Request	-	Preliminary Drawing for Fieldview Addition Being a Replat of Gardenview Acres Lot 1
Location	-	0 Greystone Parkway
Applicant / Developer	-	Deon Davis 2460 N. Reynolds Road Toledo, OH 43615
Surveyor / Engineer	-	Lewandowski Engineers, A Verdantas Company 219 S. Erie Street Toledo, OH 43604

The staff recommends that the Toledo City Plan Commission **approve** S24-0016, a Preliminary Drawing for Fieldview Addition Being a Replat of Gardenview Acres Lot 1, for the following **two (2) reasons**:

PRELIMINARY PLAT  
TOLEDO CITY PLAN COMMISSION  
REF: S24-0016  
DATE: March 13, 2025  
TIME: 2:00 P.M.

# PRELIMINARY PLAT WITH BUILDINGS

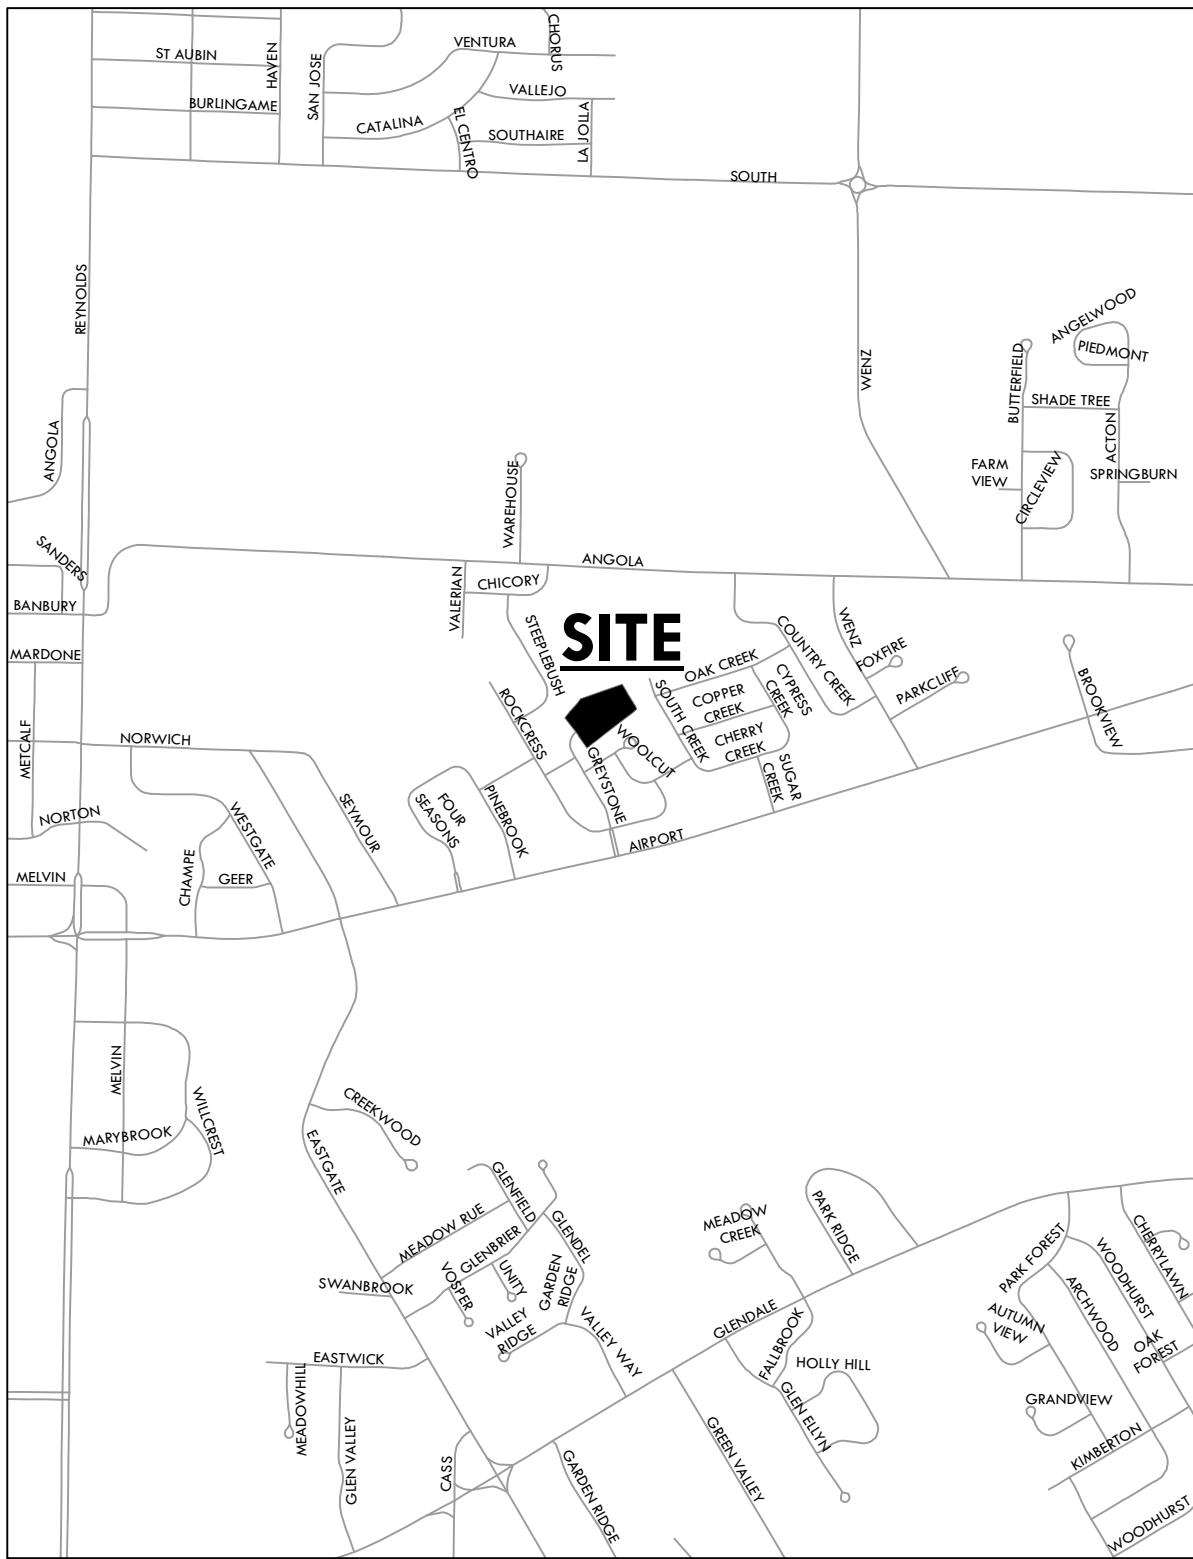
5. Water service for this development is available subject to the Rules and Regulations of the Department of Public Utilities.
6. Maintain a minimum of 10 feet of clearance between the proposed water main and proposed storm and sanitary sewers. Maintain a minimum of 10 feet of clearance between proposed hydrants and proposed storm and sanitary sewers.

7. The stormwater planning is adequate for a preliminary plat, although Toledo has not received engineering work by which it could be confirmed that the proposed detention will suffice for stormwater management needs. Confirmation is recommended prior to the final plat. The basin design shall conform the Toledo Infrastructure Standards and Ohio CGP and it shall be drained by gravity unless a defense is made and accepted that a pump must be used. Should any stormwater landscape changes be made in the process of receiving engineering approval, further coordination with the Plan Commission may be required to receive engineering approval.

10. Sanitary sewer shall be completely within the proposed right-of-way. Sanitary sewer shall be a minimum of 10 feet inside of the proposed right-of-way.

13. A Fire Hydrant is required to be placed on the extension of Greystone Pkwy. The closest fire hydrant is on Greystone at Shale Lane, which puts the end of Greystone Pkwy addition at 500 feet from the closest hydrant. Toledo Municipal Code requires a hydrant within 350 feet and the Ohio Fire Code requires a hydrant within 400 feet. (OFC 507.1 and 507.5.1, TMC 1511.03, rule 5, #1)
